Agenda Item 3
10 N. Mayflower Road
New House on a Vacant Lot

STAFF REPORT AND RECOMMENDATION

TO: Chairman Culbertson and members of the Historic Preservation Commission
DATE: November 19th, 2025
FROM: Luis Prado, Assistant Planner
SUBJECT: **10 N. Mayflower Road – Significant demolition, replacement addition, alterations to the remaining portion of the residence and site plan modifications including the addition of a pool and a concept for a future garage.**

ELEVATIONS
NOVEMBER 19, 2025

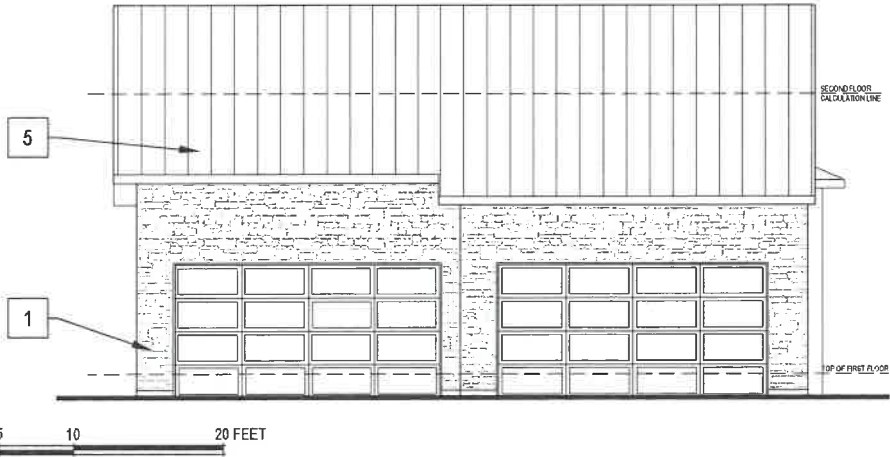
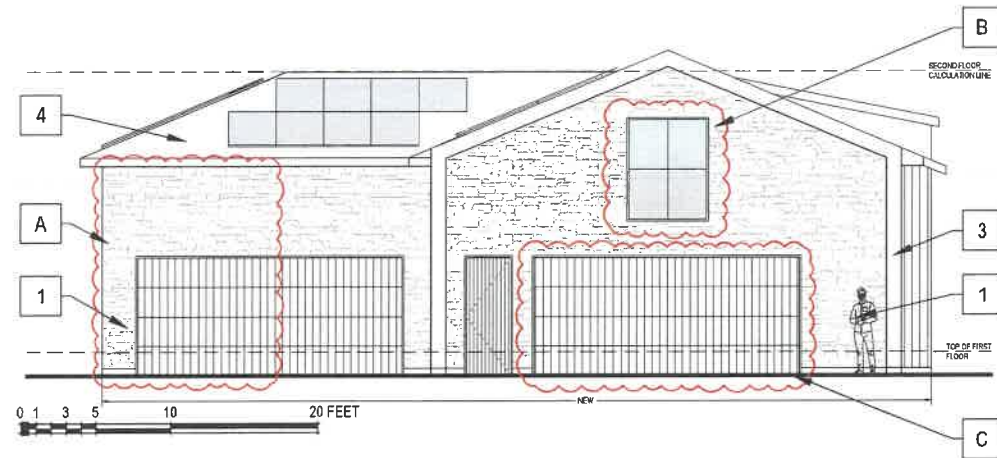
This standard is more closely met than in the previous plan. The footprint of the house was straightened, the height of the garage gable was raised from 22' to 26'7", and the width of the front entrance was narrowed.

This standard is met. The windows were refined to be consistent in style, proportions, and shape around the home. The rear windows on the rear elevation have been reduced since the October meeting. In past discussions, the Commission acknowledged the appropriateness of more fenestration on the rear elevation to take advantage of views to the rear yard.

This standard is met. As noted above, modifications were made to the windows to create a better balance the relationship of solids to voids particularly on the front elevation.

This standard is met. By straightening the footprint and eliminating dormers, the roof shapes are now regular throughout and consistent with the selected style of architecture.

104 ROOF PLAN
SCALE: 3/32" = 1'-0"

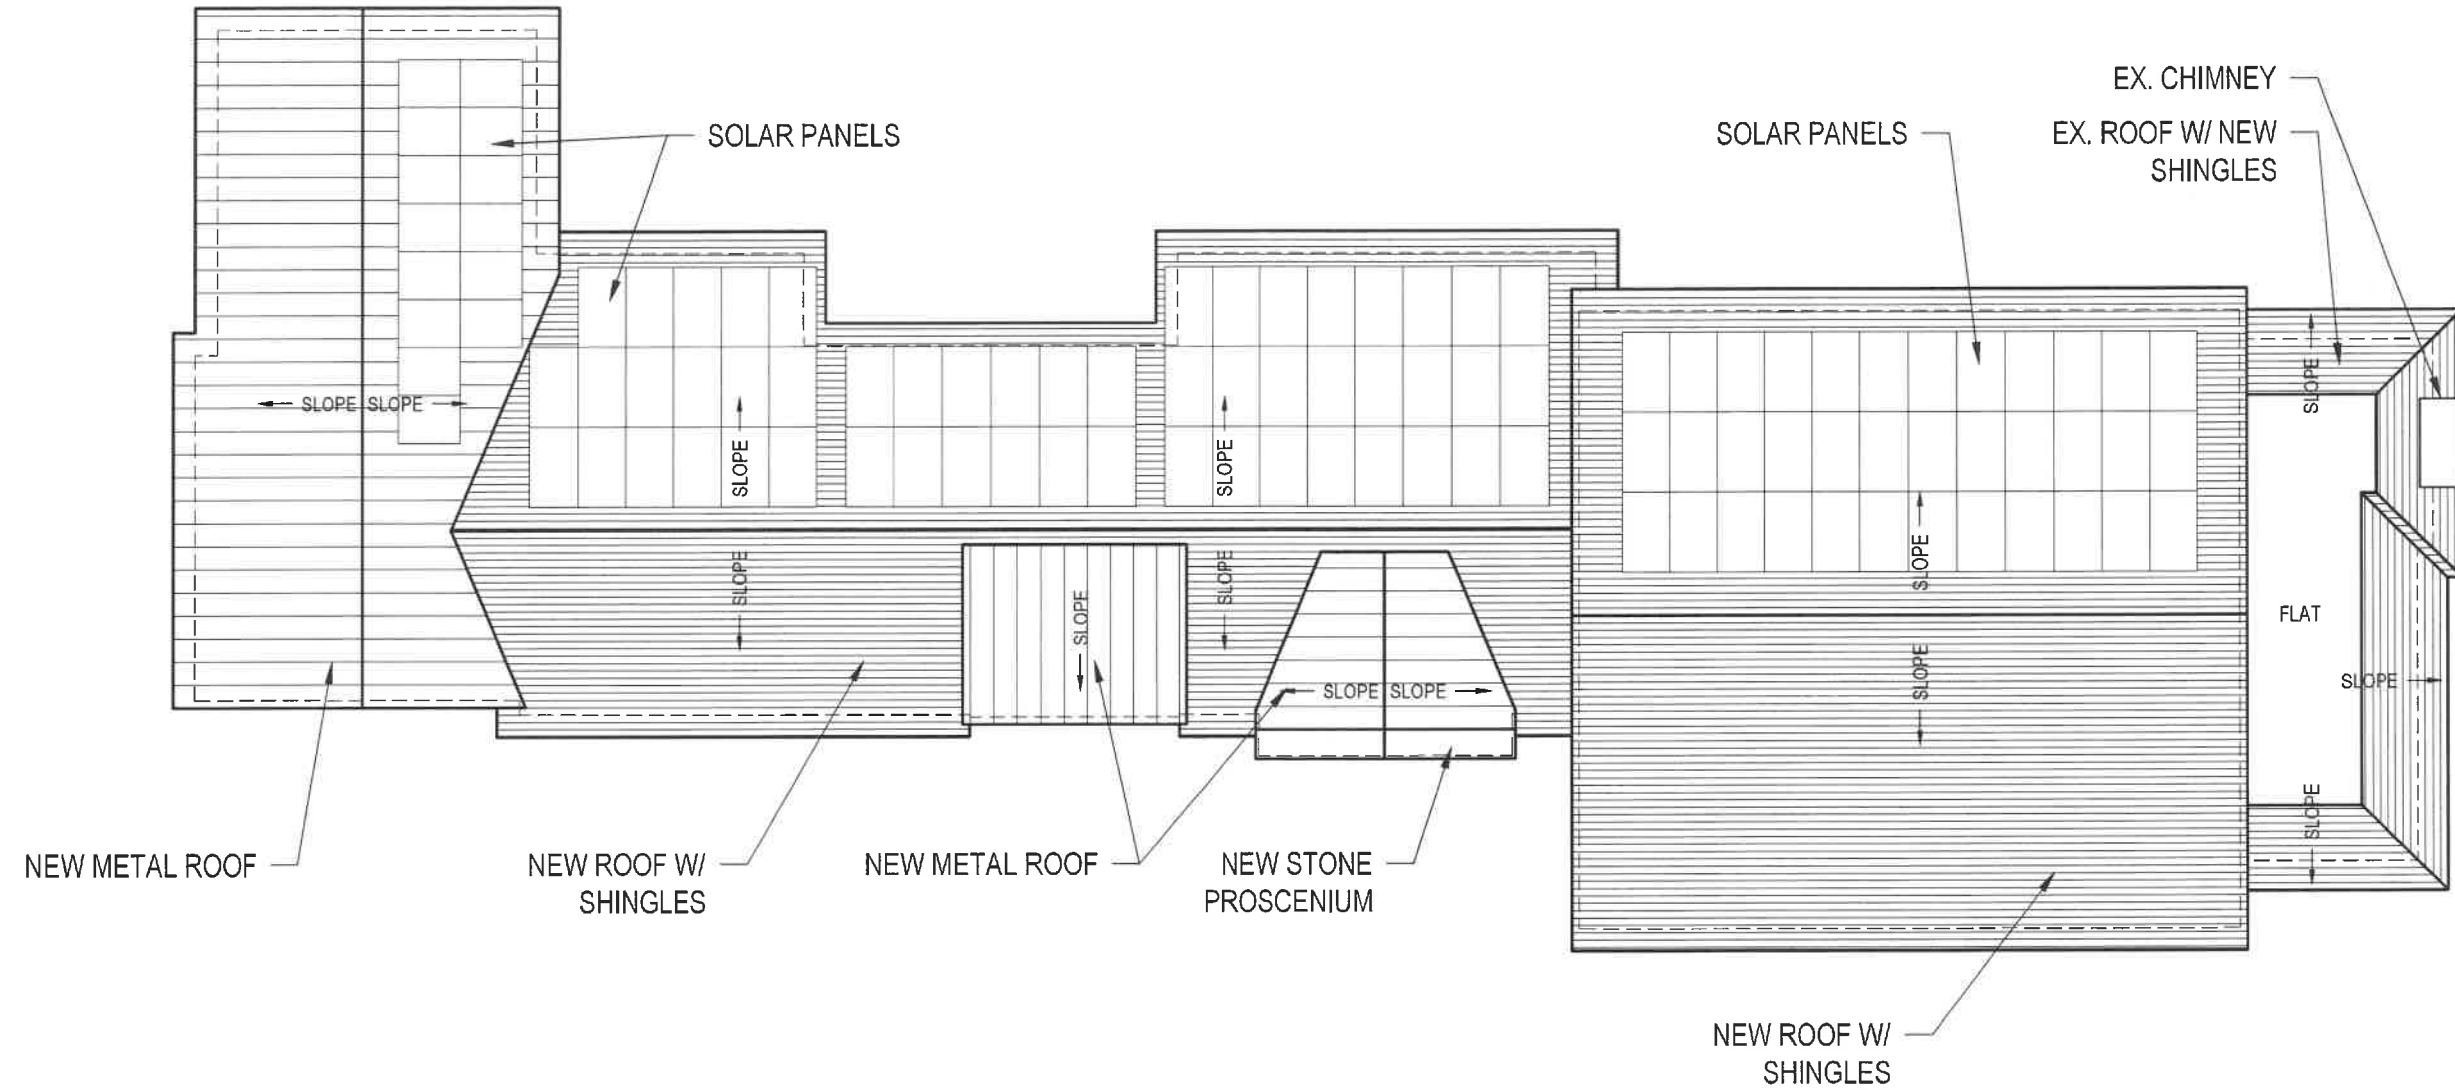
KEY NOTES	
1	STONE - HALQUIST
2	WOOD SIDING - ANTHRACITE
3	METAL - CLADDING
4	ROOFING - SHINGLES
REVISION NOTES (CLOUDED AREAS)	
A	ATTACHED GARAGE INCREASED BY (1) CAR, EXTERIOR MATERIAL CHANGED TO STONE
B	WINDOW ADDED ABOVE GARAGE DOOR
C	GARAGE DOORS TO MATCH WOOD SIDING

FUTURE GARAGE - PROPOSED FOOTPRINT

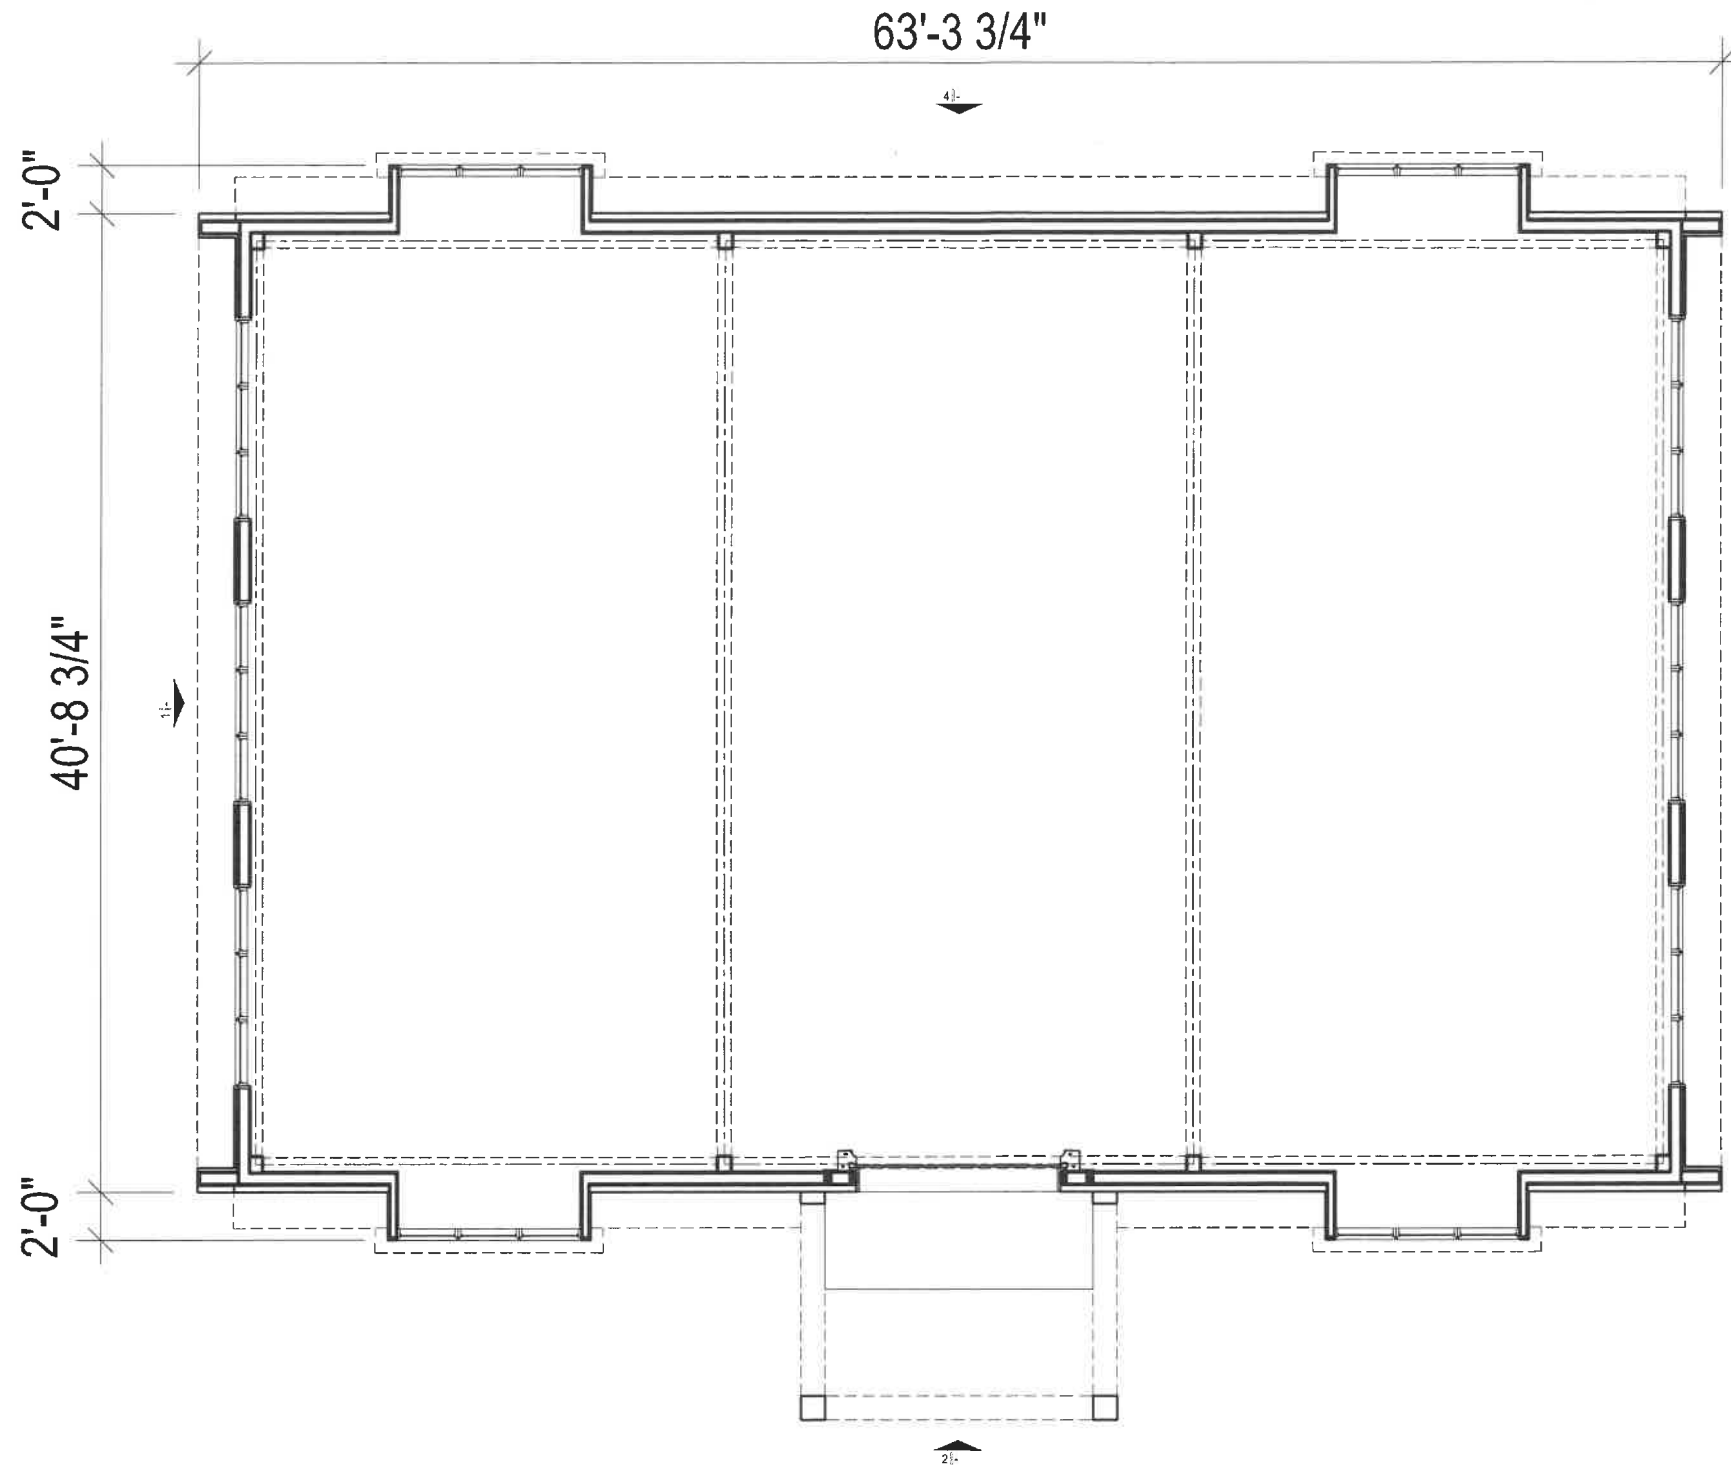
1. An updated building scale workbook along with fully dimensioned plans shall be submitted reflecting the changes to the footprint.
2. The conceptual detached garage, shown in the plans, is not considered as a part of this approval and, if the owner should wish to pursue the construction of the garage, shall submit plans for consideration at that time.
